RE: BZA #19659: Sheridan-Kalorama Neighborhood Council (“SKNC”)’s response to the February 7, 2018 submission of the Federation of State Medical Boards Inc.

Subject: **GFA ANALYSIS AND REPORT**
BZA CASE #19659
2118 LEROY PLACE, NW
Lot 49 Square 2531

SKNC EXHIBIT "AA"

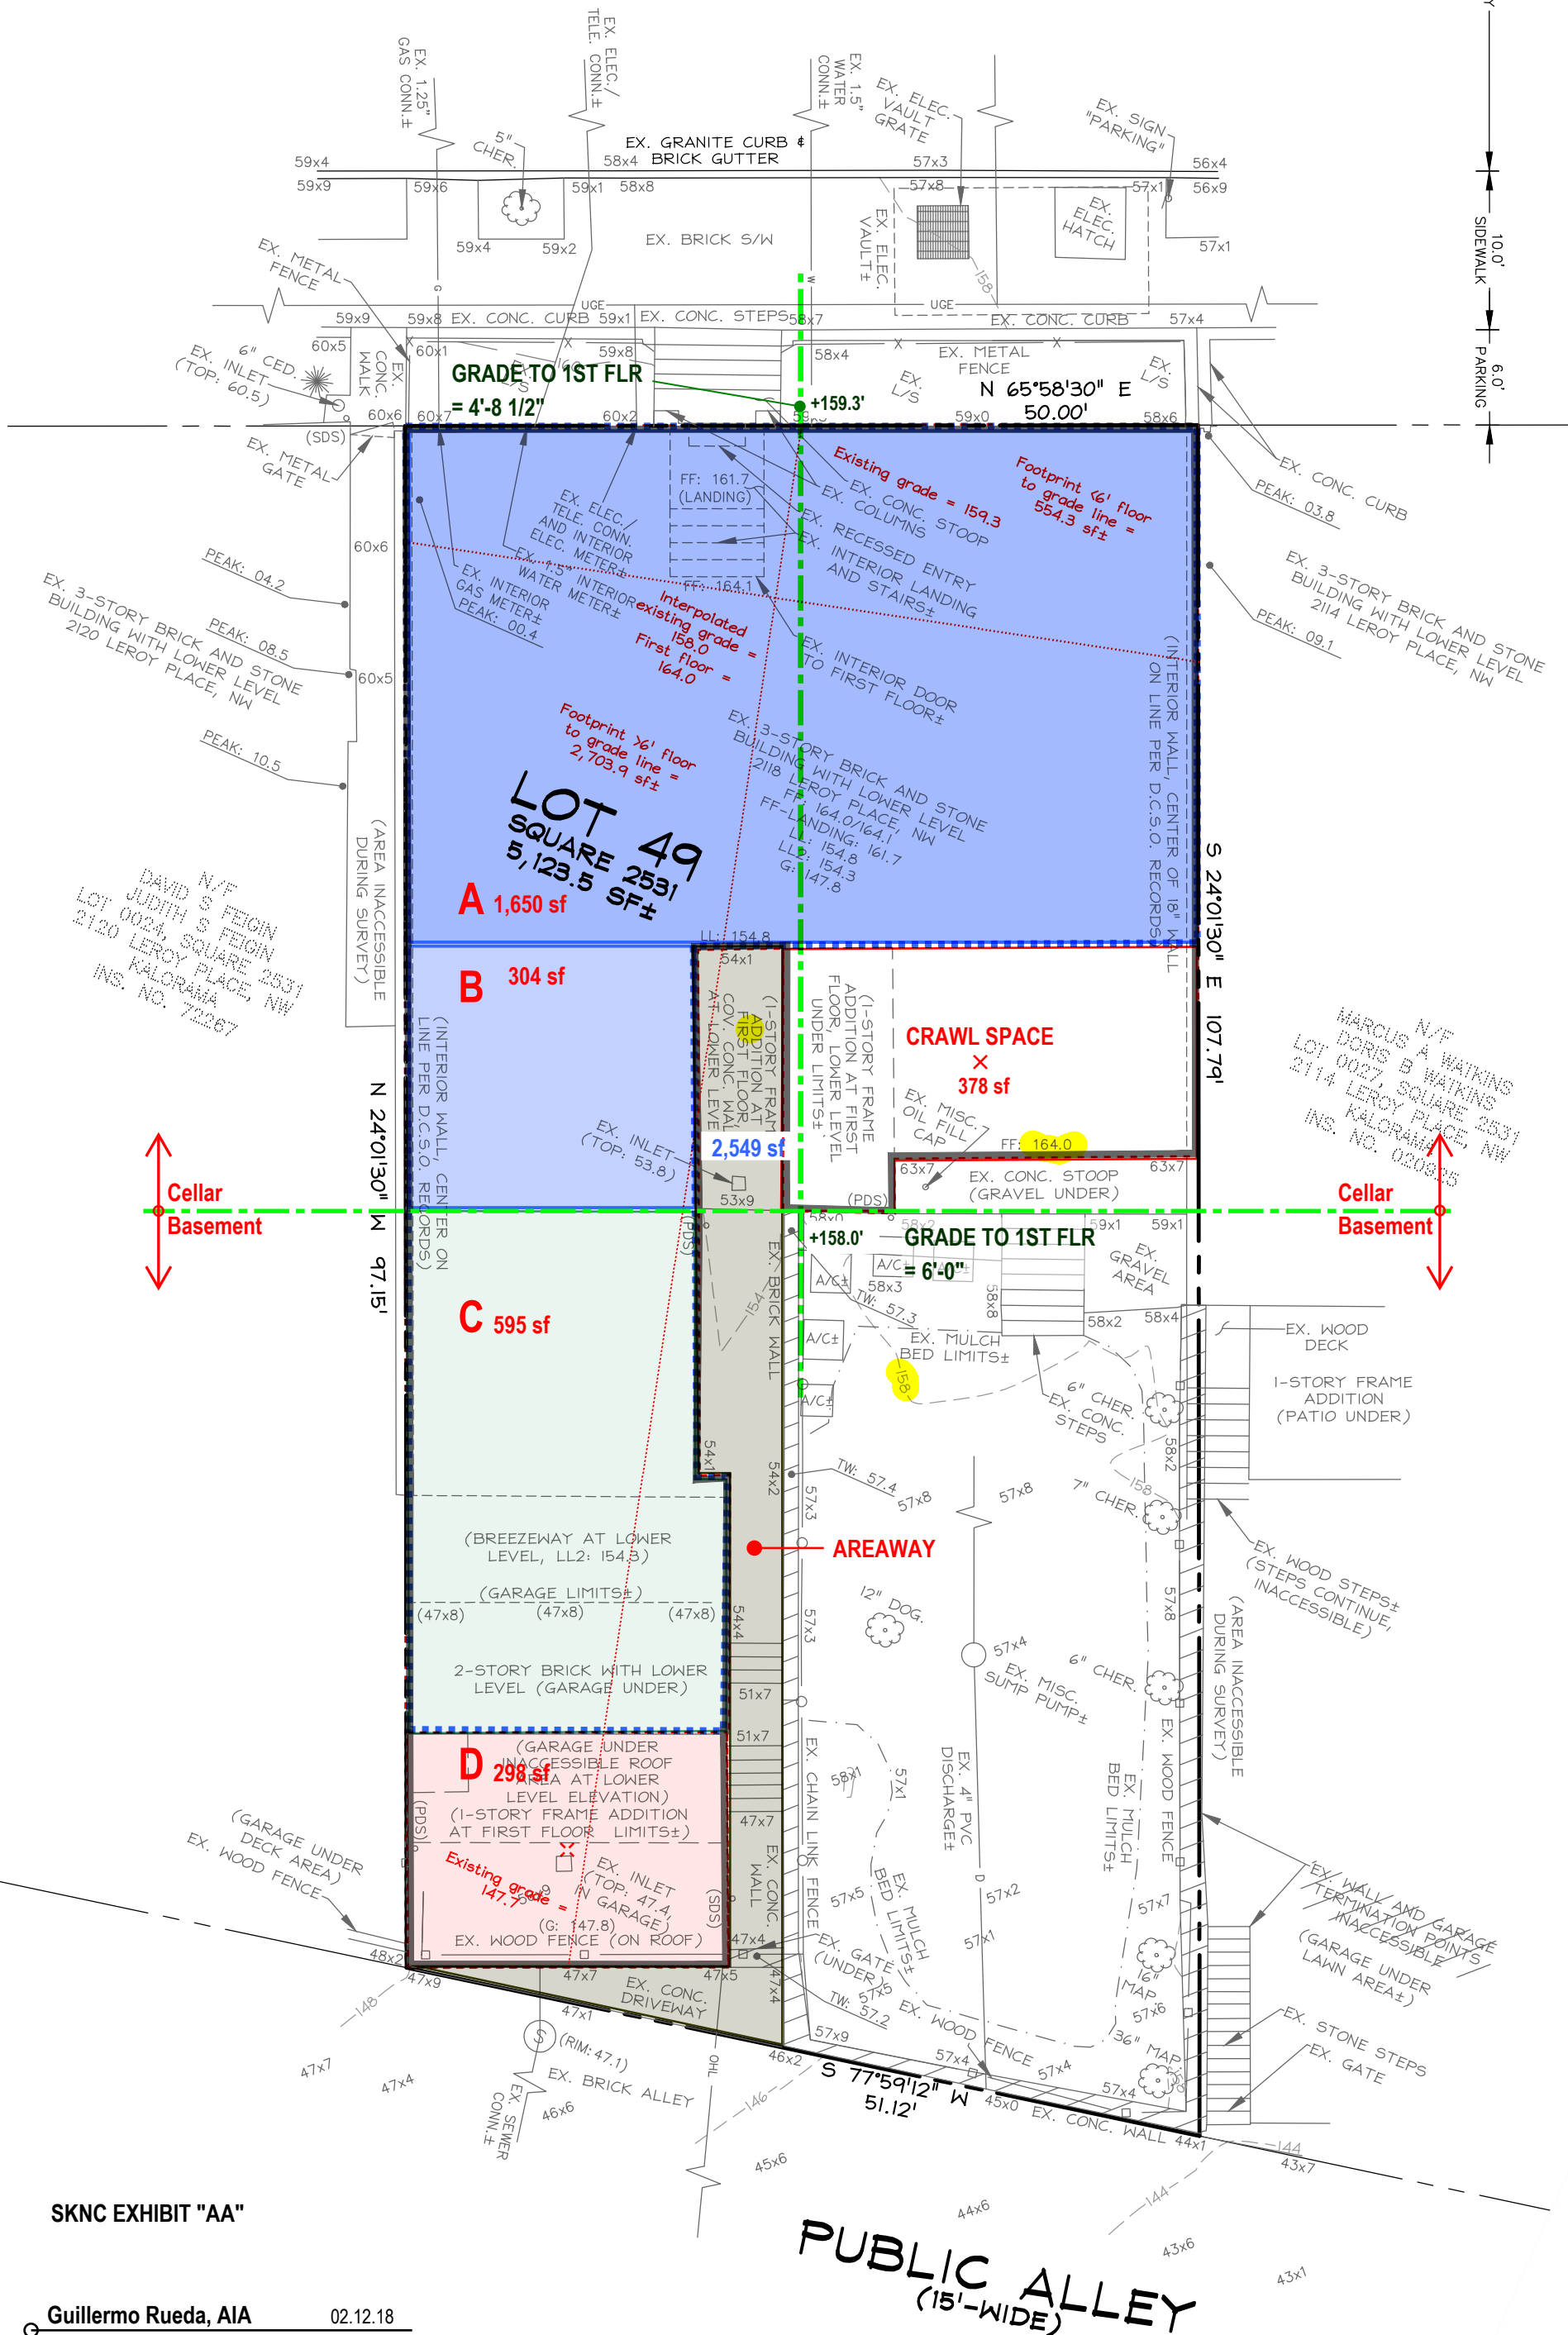
- b. **SKNC Exhibit "AA"** further highlights the 298 sf (red) area "D" that does not extend to LL2 or LL. Therefore, adding the values from A, B, and C yield a total LL, LL2 footprint of 2,549 sf (not 3,258 sf).

- c. SKNC Exhibit "AA" documents the correct method for interpreting grade for attached buildings.
 - i. The *finished grade*⁵ at the midpoint of the building facade nearest to Leroy Place is 4' 8" below the *ground floor* (1st floor).

- ii. A line from the Leroy Place grade point connects to the midpoint at the opposite building facade where the ground abuts the building (*finished grade*) and emerges 6' below the *ground floor*, the exact datum that defines area that contributes to GFA in accordance with Subtitle B-304.5 (d).

- iii. The grade plane line that connects the two facades would therefore indicate that portion of the lower level is less than 6' from the ground floor and the area shown in blue (1,954 sf) should not be counted towards gross floor area.

- iv. As the rear yard grade continues level from where it emerges at the opposite facade, the remaining (595 sf) floor area on this level should be considered *basement* area counted towards the GFA.

SKNC EXHIBIT "BB"

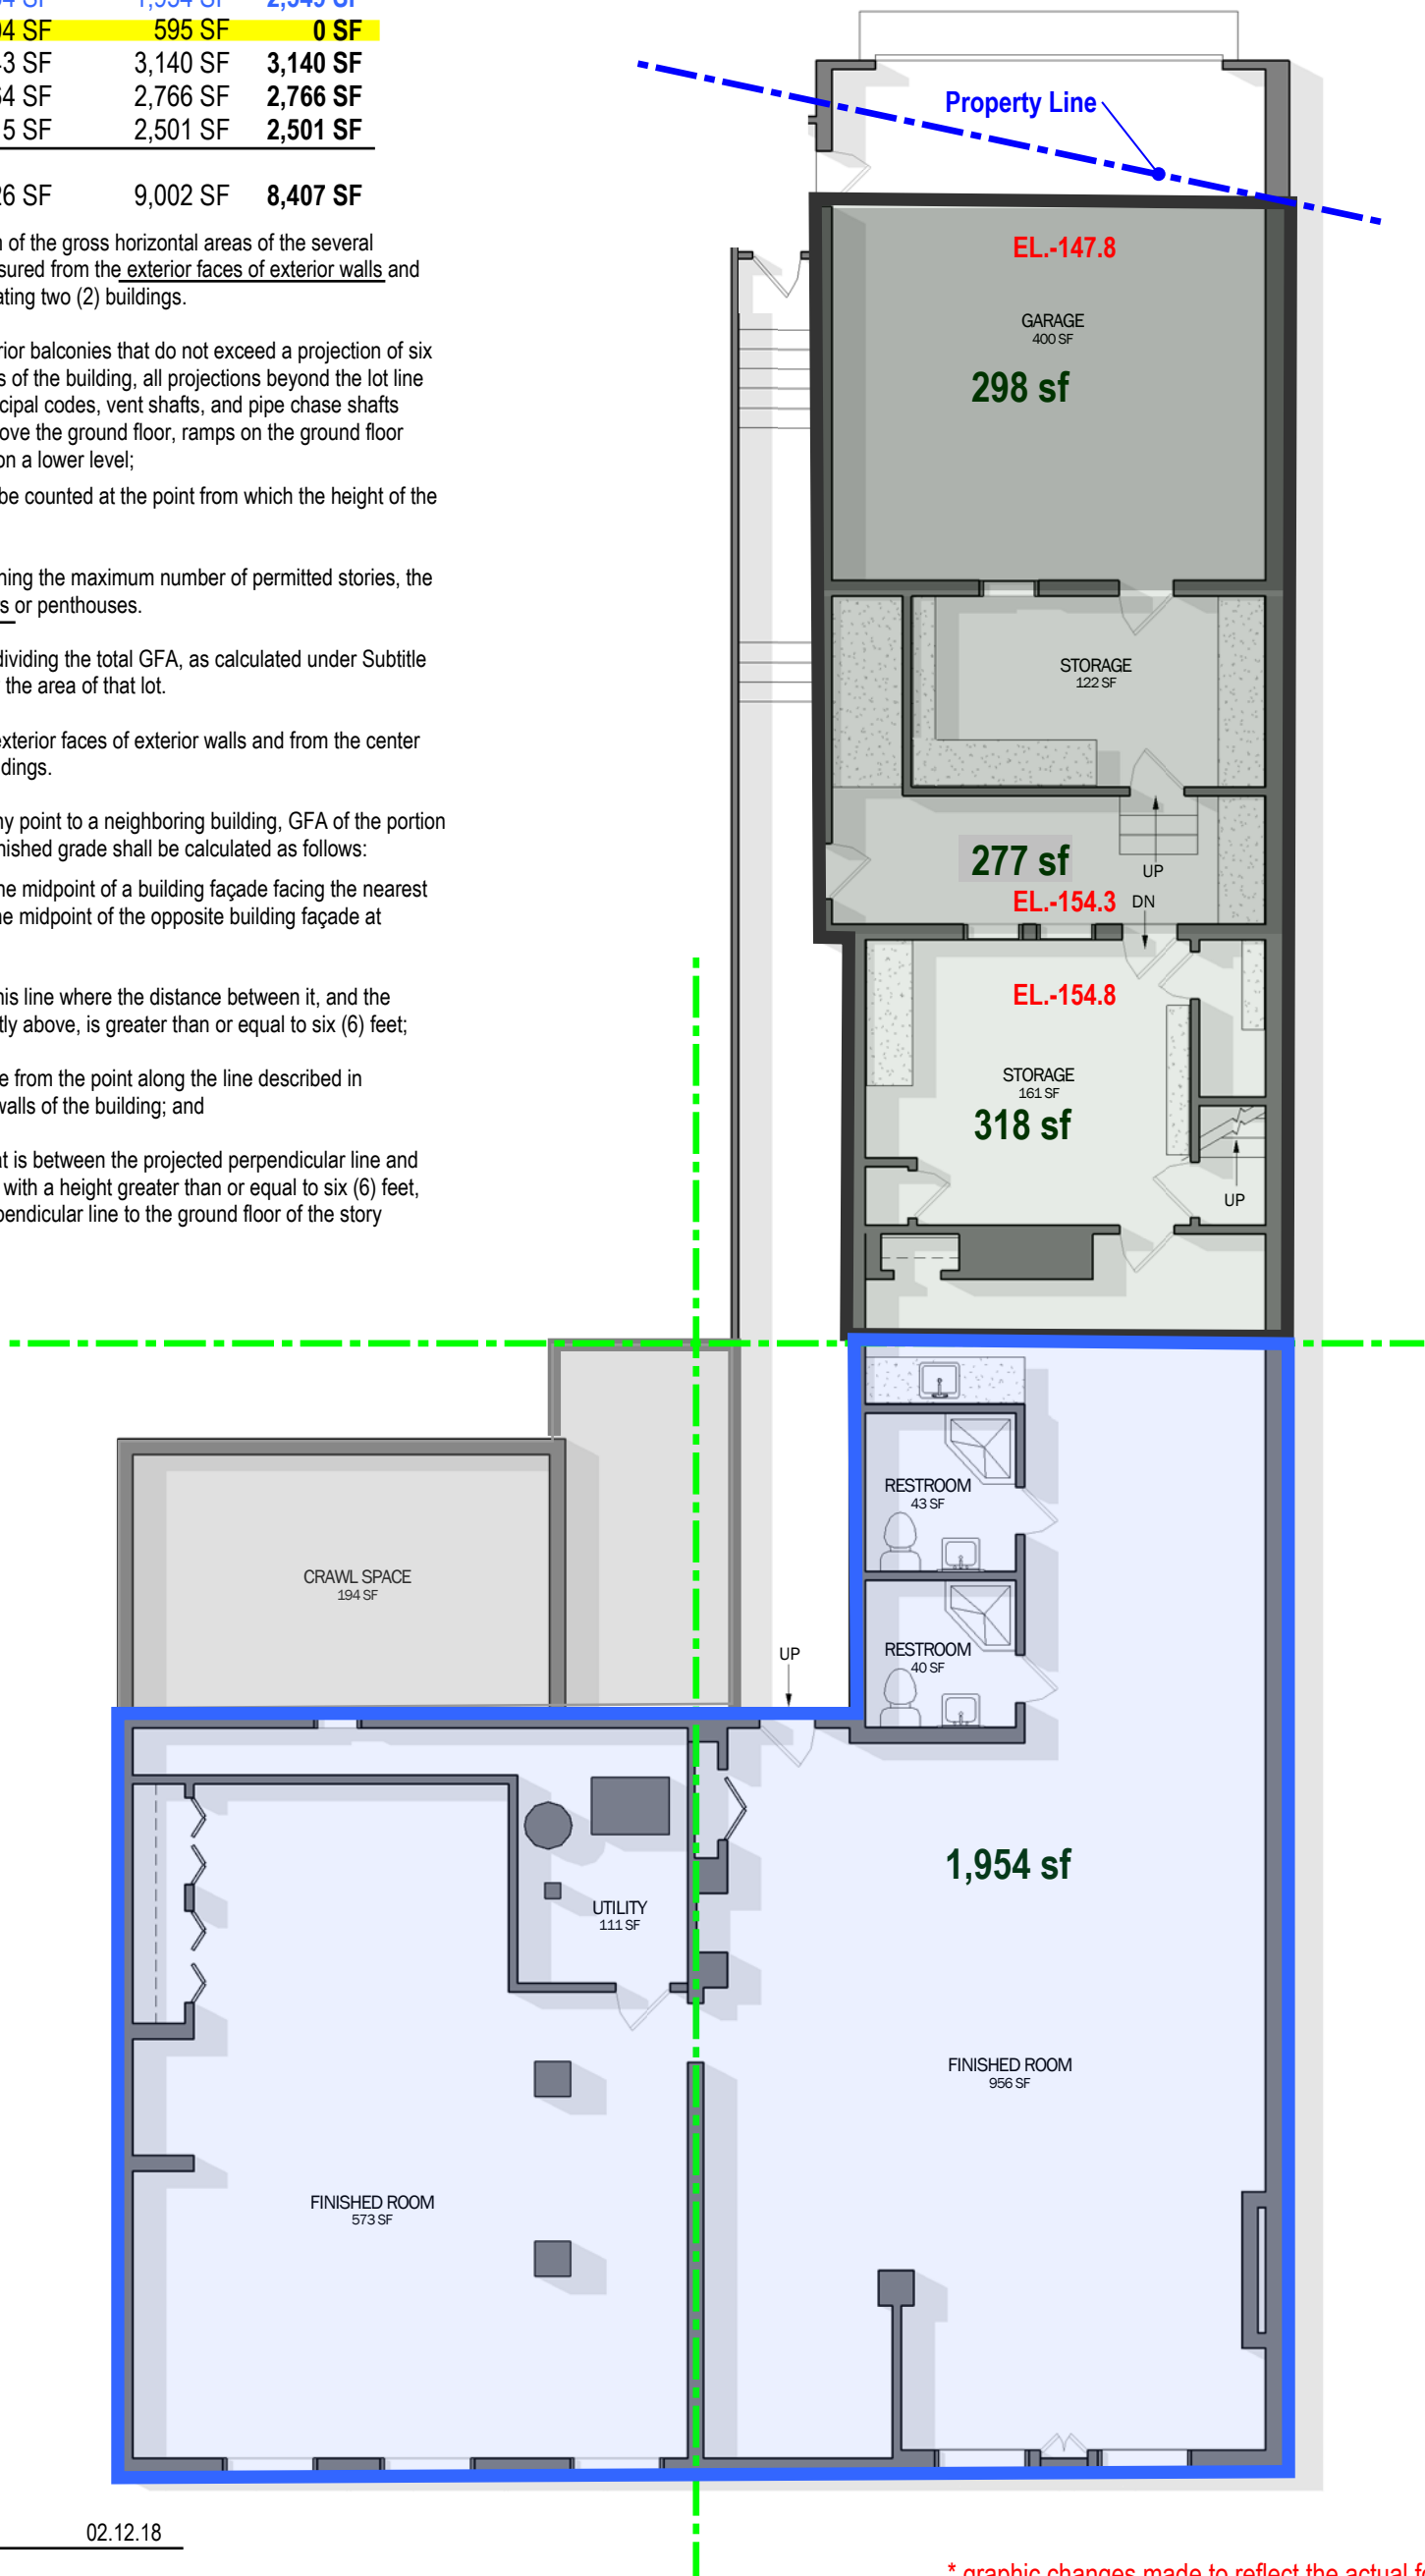
- c. **SKNC Exhibit "BB"** shows that the 'flattened' lower level building plan as drawn is not only incorrect for area measured and levels, but also differs in overall length from that of the CAS-DC survey, and extends about 8' beyond the as-built condition (into the alley).

SKNC EXHIBIT "CC"

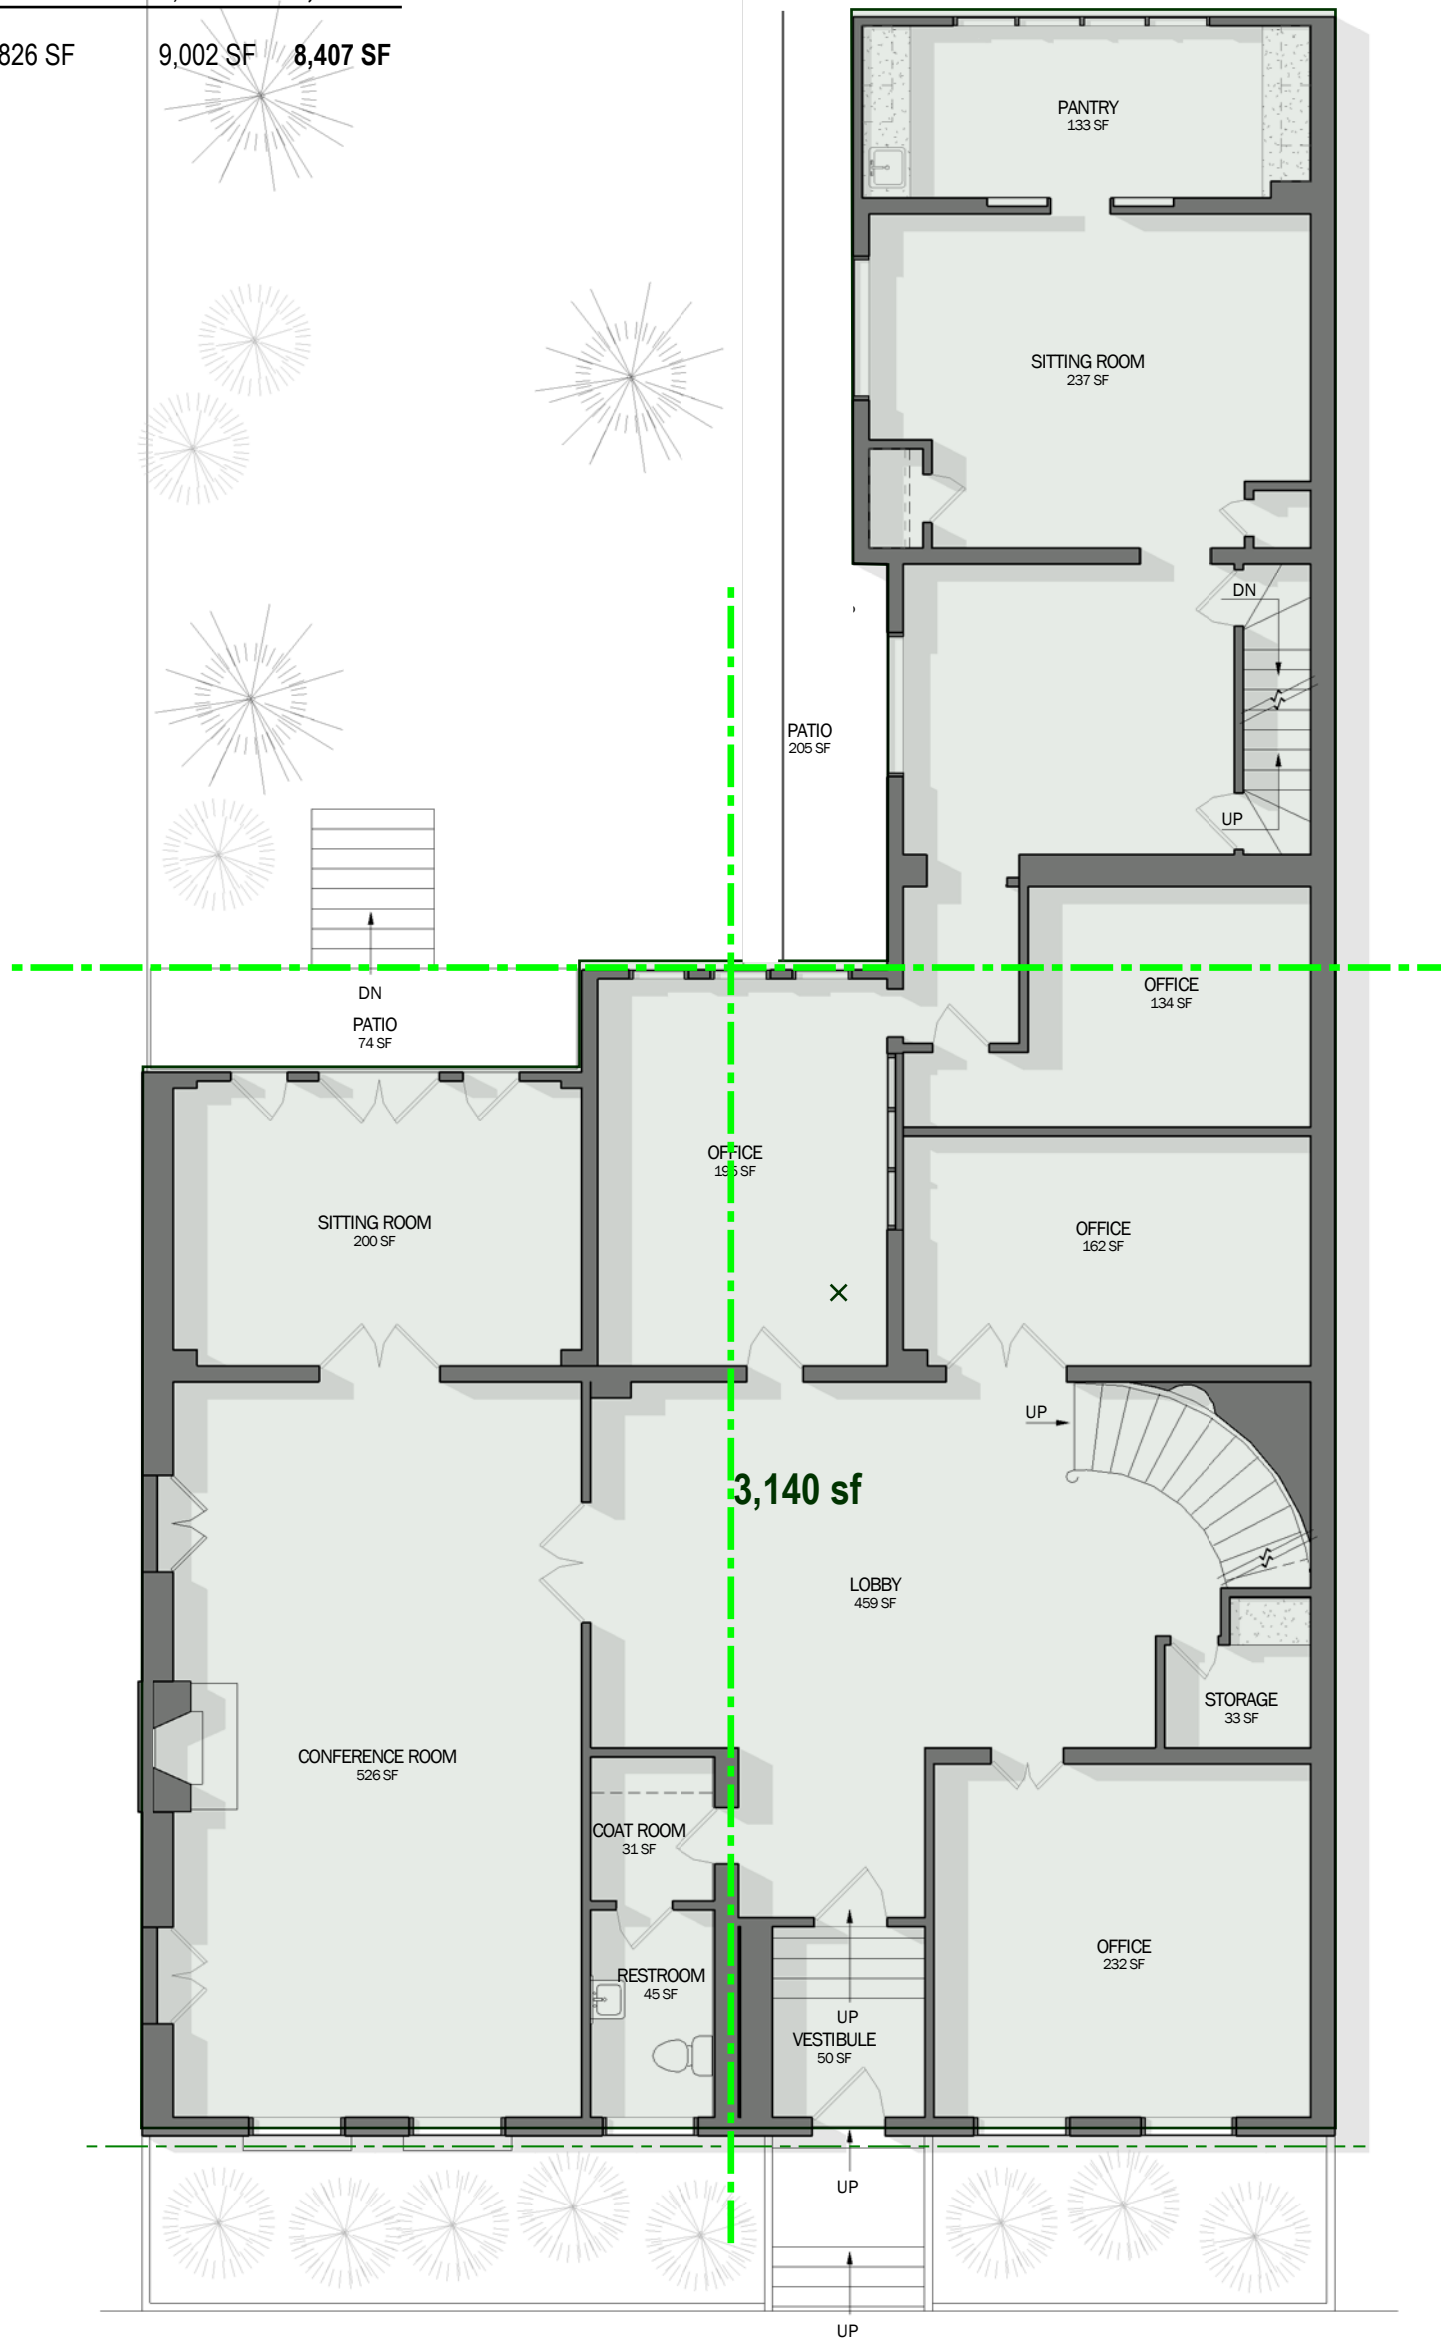
- d. It was further determined that the applicant's Exhibit "A" calculates GFA to the inside face of the exterior wall, contrary to the definition of GFA in Subtitle B-100.2, incorrectly excluding the thickness of the wall. The required additional wall area of the upper floors is, therefore, included in the final GFA calculation below.

- e. The CAS-DC survey provides an accurate measure of the building footprint, but the upper-level plans could not be evaluated for accuracy. GFA shown in **SKNC Exhibits "CC-EE"** for levels 1,2, and 3 was based on the submitted plans with the caveat described above in (d).
